SITE DEVELOPMENT PLANS FOR BANK OF AMERICA

SECTION 15, TOWNSHIP 27, RANGE 24 BLOOMINGTON, HENNEPIN COUNTY, MN

SHEET NUMBER
C400

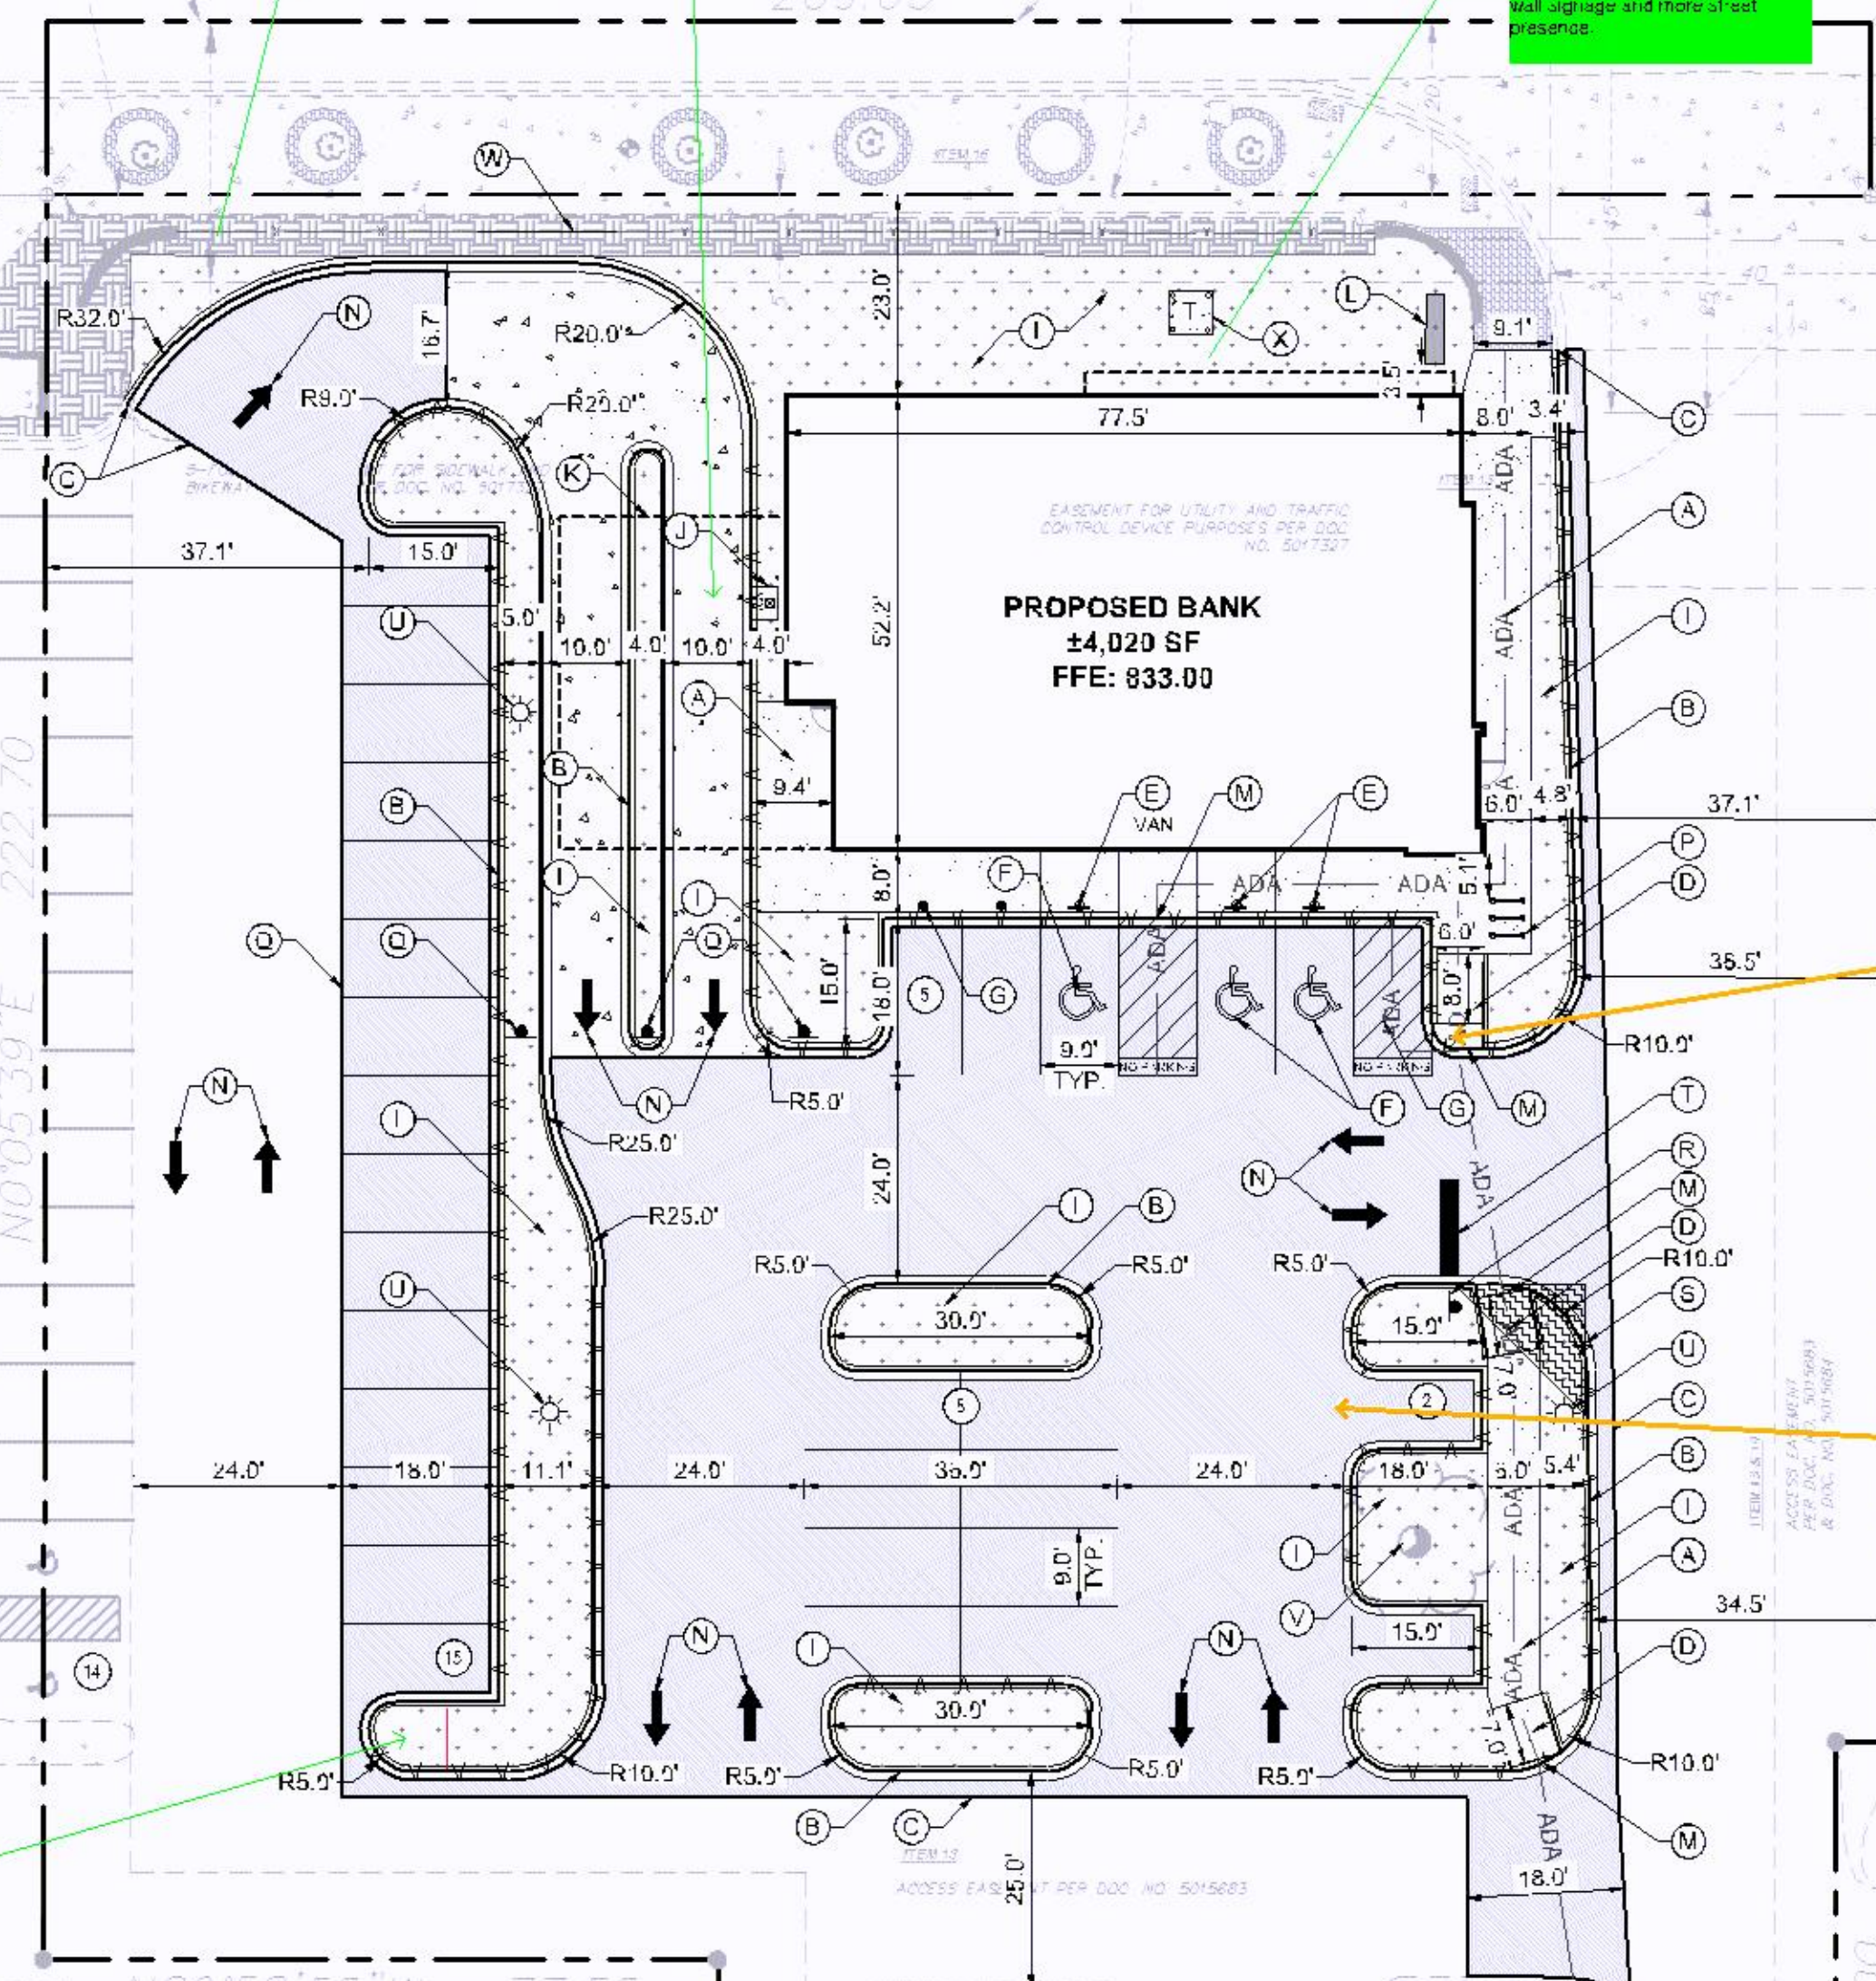
Drive through must be screened from public street (Sec. 21.301.02(f)(7)) by extending a wall from the north west corner or installing evergreen plantings.

Bank estimates that there are four stacking spaces available for the drive-thru sign. Minnesota City Code Sec. 21.301.05(a) requires six stacking spaces. Please clarify if you are seeking a deviation to reduce the number of drive-thru stacking spaces.

Can the building be shifted further north? Moving the building north would provide greater visibility to wall signage and more street presence.

Try to line up the north-south sidewalk so the crosswalk is straight across the driveway. As shown a user has to turn around the building, there may not be enough clearance if the bike rack is in use and the crosswalk will be angled across the driveway.

Add bike rack installation detail that shows rack type as well as spacing and required clearance around each rack.

I think you need to add parking stall markings to these two stalls since there are no existing cues that the stalls extend beyond the curb.

Parking island must have eight feet of internal width.

SHEET NUMBER
C500

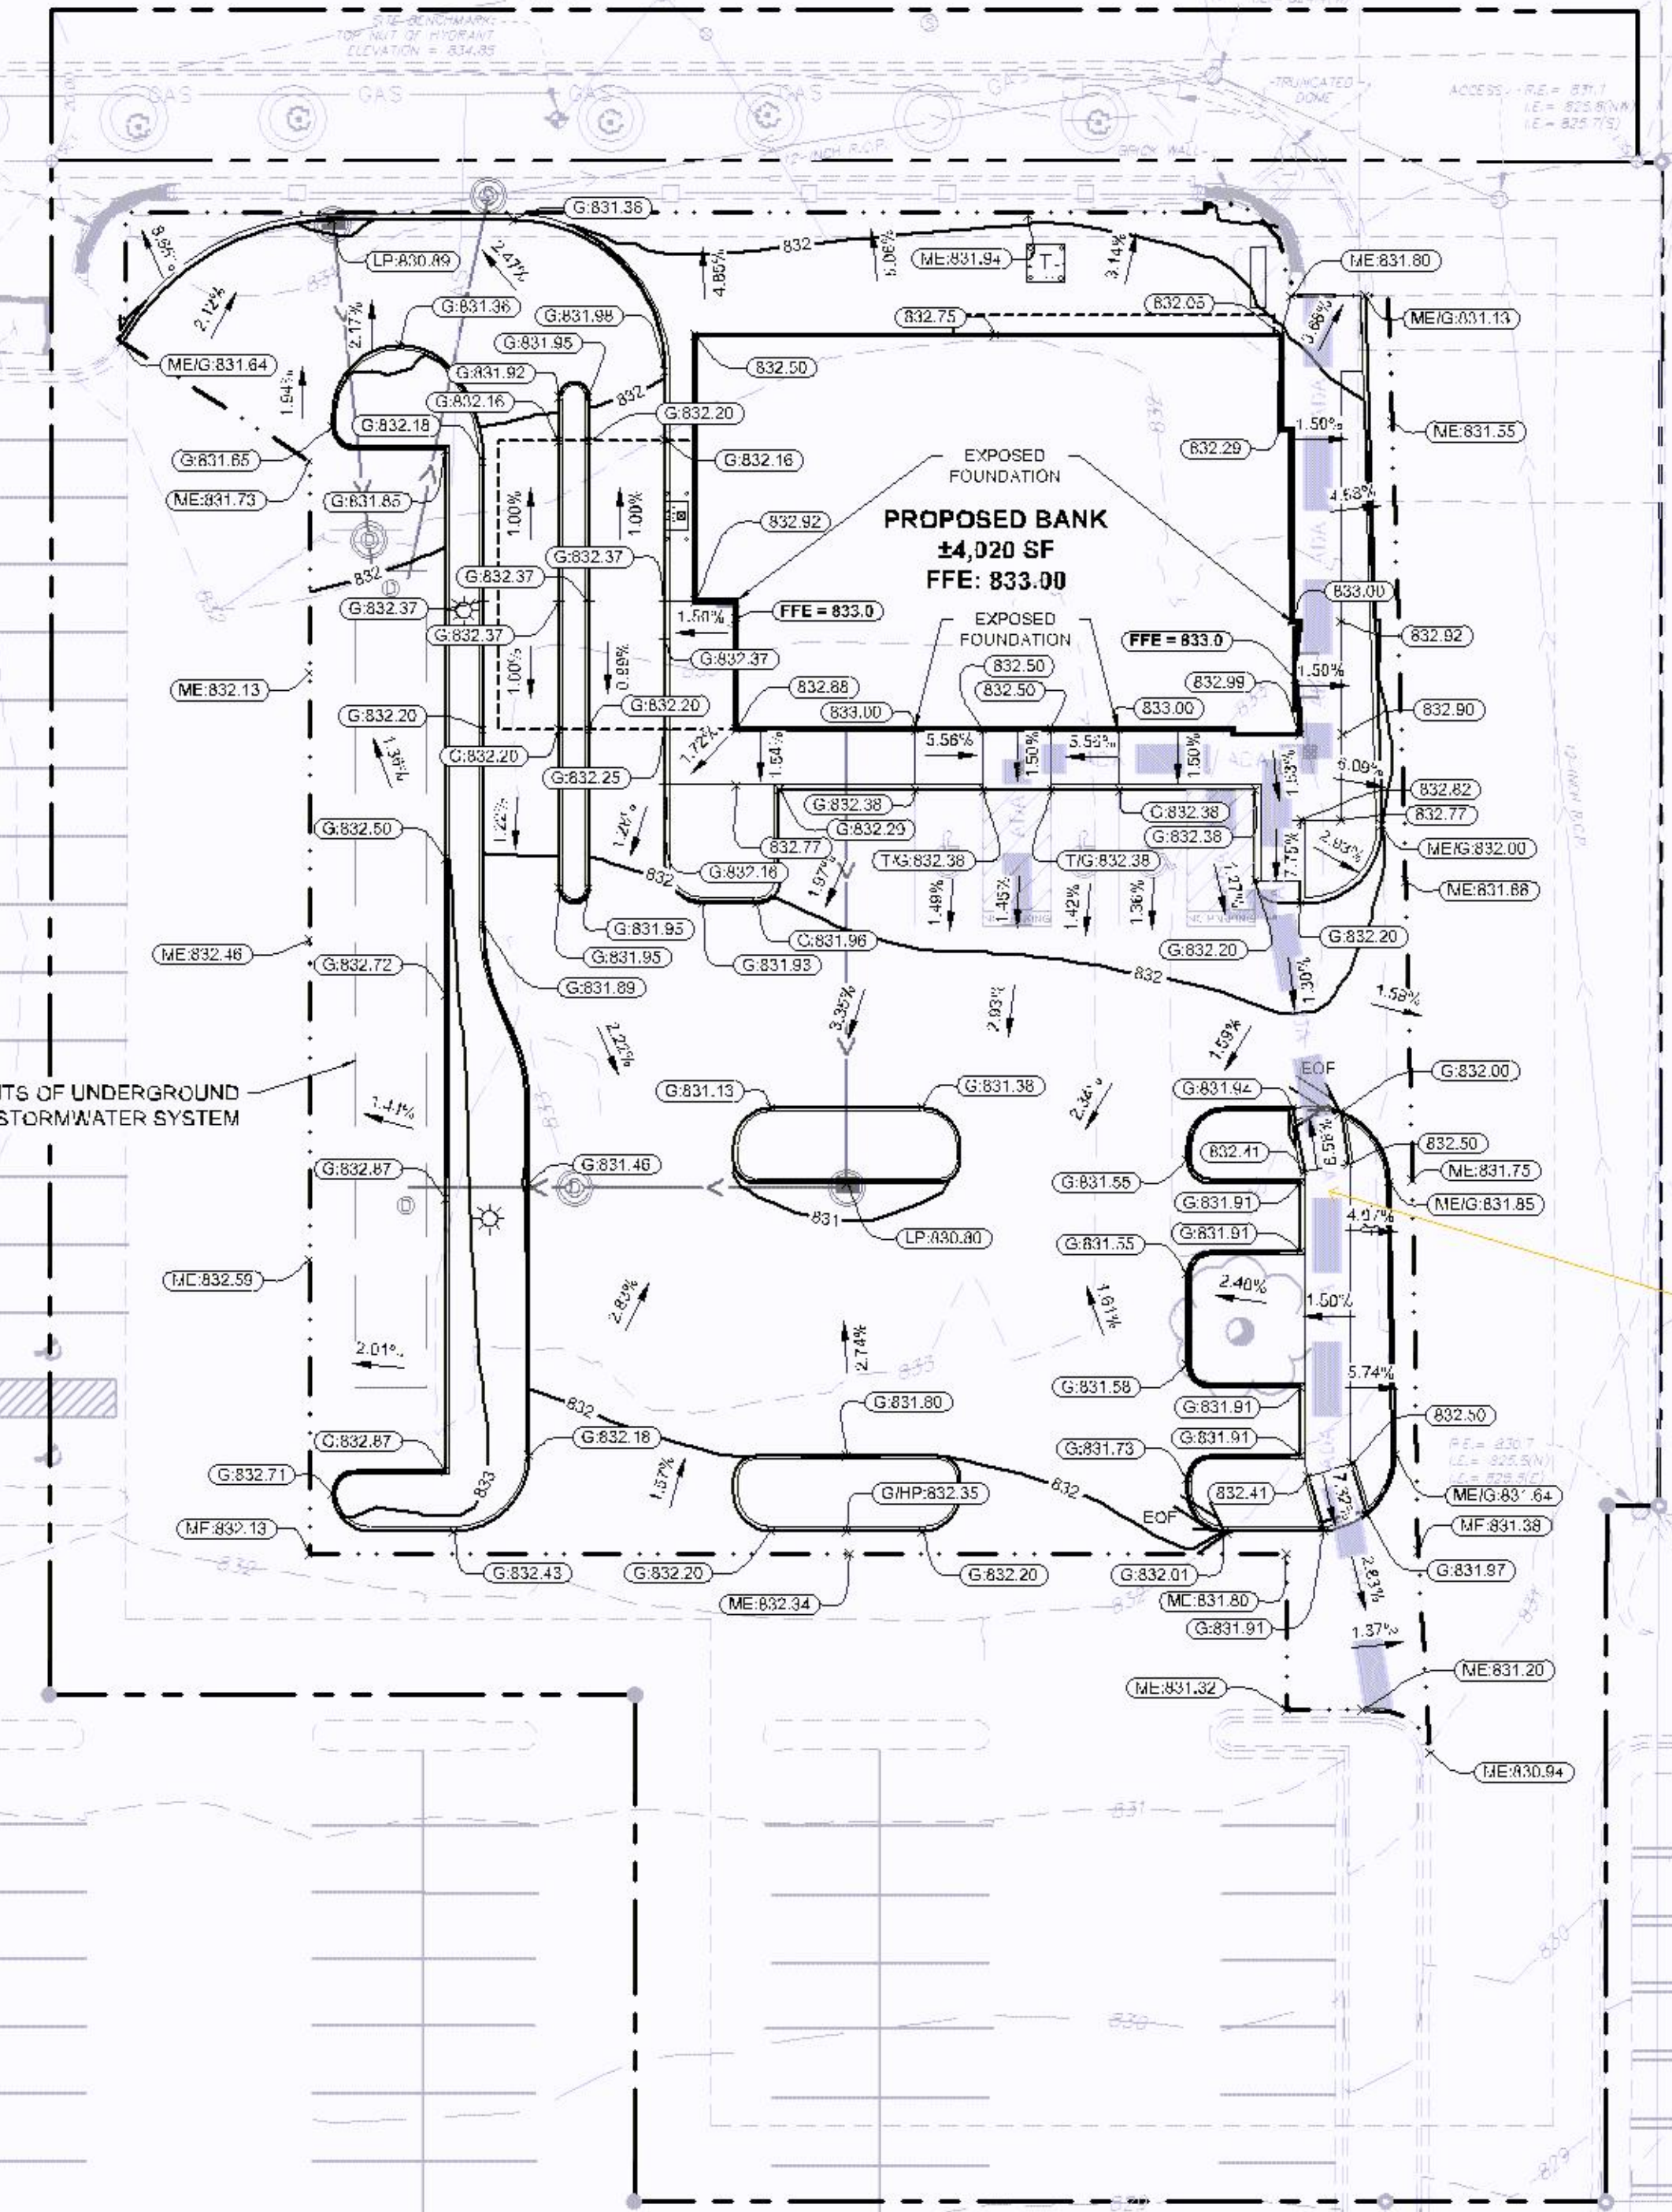
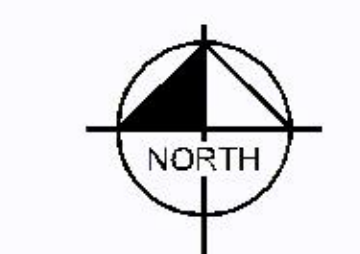
Ensure that there are landing areas of 2% or less grade adjacent to pedestrian ramps that are between 5-8.3%
